Southern Nuclear Operating Company  
Vogtle Electric Generating Plant Units 3 and 4  
Revision 2 to Request for License Amendment:  
Use of AWS D1.1-2000 Criteria for Structural Welds (LAR-15-009R2)

**Southern Nuclear Operating Company**  
**Vogtle Electric Generating Plant (VEGP) Units 3 and 4**

**Revised Request for License Amendment Regarding**  
**Use of AWS D1.1-2000 Criteria for Structural Welds**  
**(LAR-15-009R2)**

**Revised Proposed Changes to Licensing Basis Documents**  
**(LAR-15-009R2)**

Figure 1. Fillet Weld Loading In-Plane of Weld

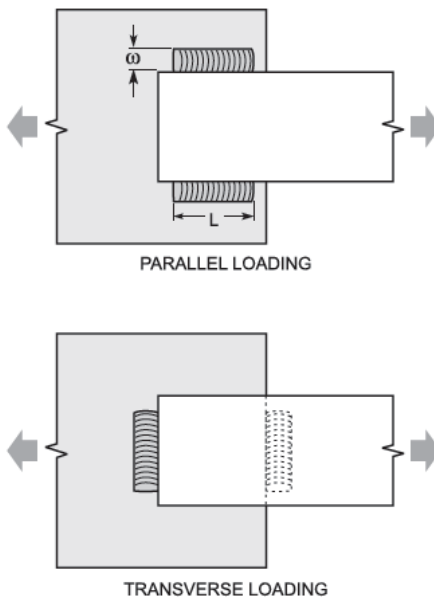
These changes are supported by industry tests that provide the justification for criteria that consider the load directionality. The testing and analysis is reported in an AISC Journal Article, “*Proposed Working Stresses for Fillet Welds in Building Construction*,” by T. R. Higgins and F.R. Preece. The referenced Higgins and Preece paper describes tests on linear fillet welds loaded both parallel to and transverse to the axis of the weld in the plane of the weld, as illustrated in Figure 1. The Higgins and Preece paper provides a factor of safety summary related to a working stress of  $0.30F_{EXX}$ . The summary of test results demonstrates that the failure of the weld loaded transverse to the axis of the weld is approximately four times  $0.30F_{EXX}$ .

For linear fillet weld groups concentrically loaded in the plane of the weld and consisting of elements oriented both longitudinally and transversely to the direction of applied load, additional provisions are proposed to be included in UFSAR Subsections 3.8.3.2 and 3.8.4.2 to supplement the provisions for directionality included in AWS D1.1-2000. These supplemental provisions address the deformation capability of the elements when combined in a weld group.

Figure 1A. Supplemental Provisions for Weld Groups with Longitudinally and Transversely Loaded Elements

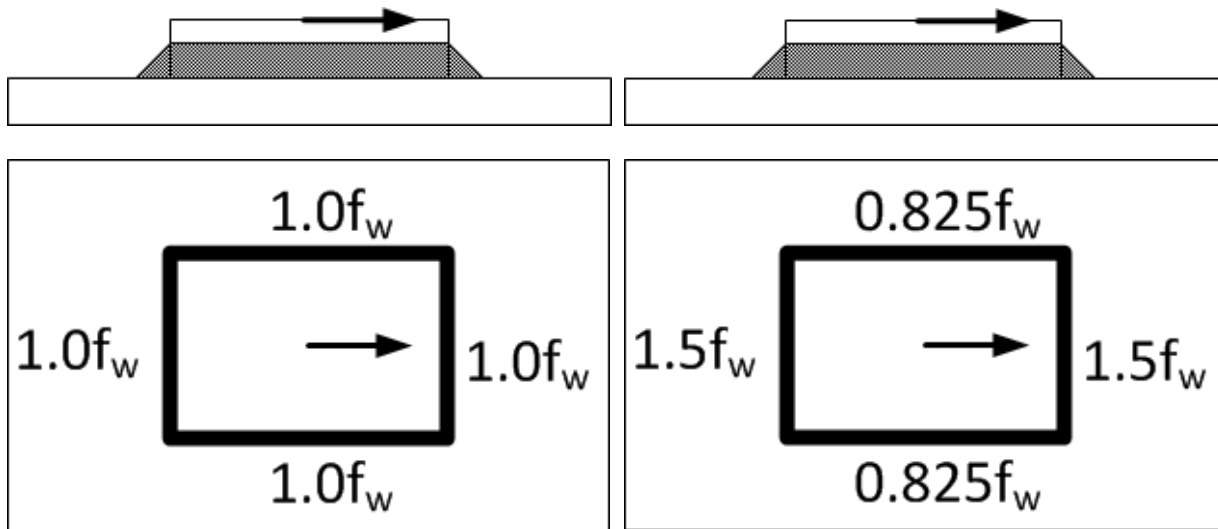
The strength of the weld group is limited to the larger of (1) the combined strength of the individual weld elements using 1.0 times the strength of the longitudinally oriented element and 1.0 times the strength of the transversely oriented element and (2) the combined strength of the individual weld elements using 0.825 times the strength of the longitudinally oriented element and 1.5 times the strength of the transversely oriented element as illustrated in Figure 1A. These supplemental provisions are more conservative than those in AWS D1.1-2000 and are consistent with provisions in AWS D1.1-2010 Section 2.6.4.4 and Table 2.4 and AISC 360-2010 Section J2.4 (c).

*For fillet weld groups concentrically loaded in the plane of the axis of the weld and consisting of elements oriented both longitudinally and transversely to the direction of applied load, the deformation capability of the elements shall be considered. As a supplement to the provisions in AWS D1.1-2000, the strength of the weld group is limited to the larger of the two following evaluations:*

Figure 3. Circular Fillet Weld Group

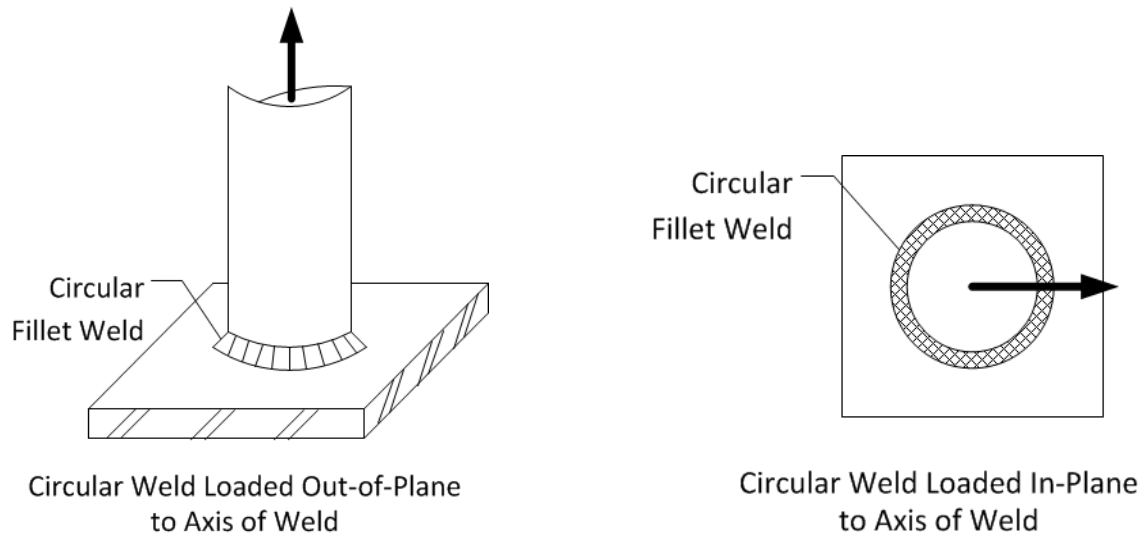
Circular fillet weld groups (e.g., fillet welds to anchor reinforcing bars, fillet welds to round rods, fillet welds to round tubes) are illustrated in Figure 3. A circular-shaped weld group concentrically loaded out-of-plane to the axis of the weld has a loading condition and behavior equivalent to a weld group consisting of straight lines because the shift in the fillet failure angle resulting in the increase in the strength of the weld occurs in the same way whether the axis of the weld is straight or circular. The parameter of interest is the angle that the applied force makes with the axis of the weld.

The FEA was then extended to compare the linear out-of-plane behavior to circular weld out-of-plane behavior. The FEA evaluates the circular weld group by creating a solid round bar circumferential-slice-model with a fillet weld circumference equivalent to the length of the fillet weld used in the tests. The circular weld length was based on the centerline projection of the 45 degree effective throat. The model of the welds used equivalent-node attachment of the nominal size of the weld to the base material. No connection was used between welds (i.e., the root notch was maintained in the models). Comparison of the stress results between the linear fillet weld on the cruciform model and the stress results for the circular weld group was performed. The stress comparison confirms that (1) the path of maximum stress through the weld occurs at approximately 74 degrees to 90 degrees from the horizontal leg for the circular fillet weld; and (2) the average equivalent stresses along the path of maximum stress for the circular fillet weld are approximately equivalent to that for the equivalent-length linear weld.

The use of directionality for circular welds is limited to tension loading concentrically applied out-of-plane to the axis of the weld. For circular welds loaded in-plane to the axis of the weld, the angle of loading measured from the weld longitudinal axis is constantly varying. Due to this complexity, application of AWS D1.1-2000 Section 2.14.4 is excluded for circular welds loaded in-plane to the axis of the weld. The limitation on the use of directionality to out-of-plane load for circular weld groups is included in the licensing basis changes in UFSAR Subsections 3.8.3.2 and 3.8.4.2.

- Where directionality is considered for concentric out-of-plane loading for linear fillet weld groups, including lines and rectangular configurations, the directionality provisions in AWS D1.1-2000 are applied.
- Where directionality is considered for concentric out-of-plane loading for circular-shaped fillet weld configurations, the directionality provisions in AWS D1.1-2000 are applied. The use of directionality provisions in AWS D1.1-2000 for circular-shaped fillet weld configurations is limited to tension loading concentrically applied out-of-plane to the axis of the weld.]\*
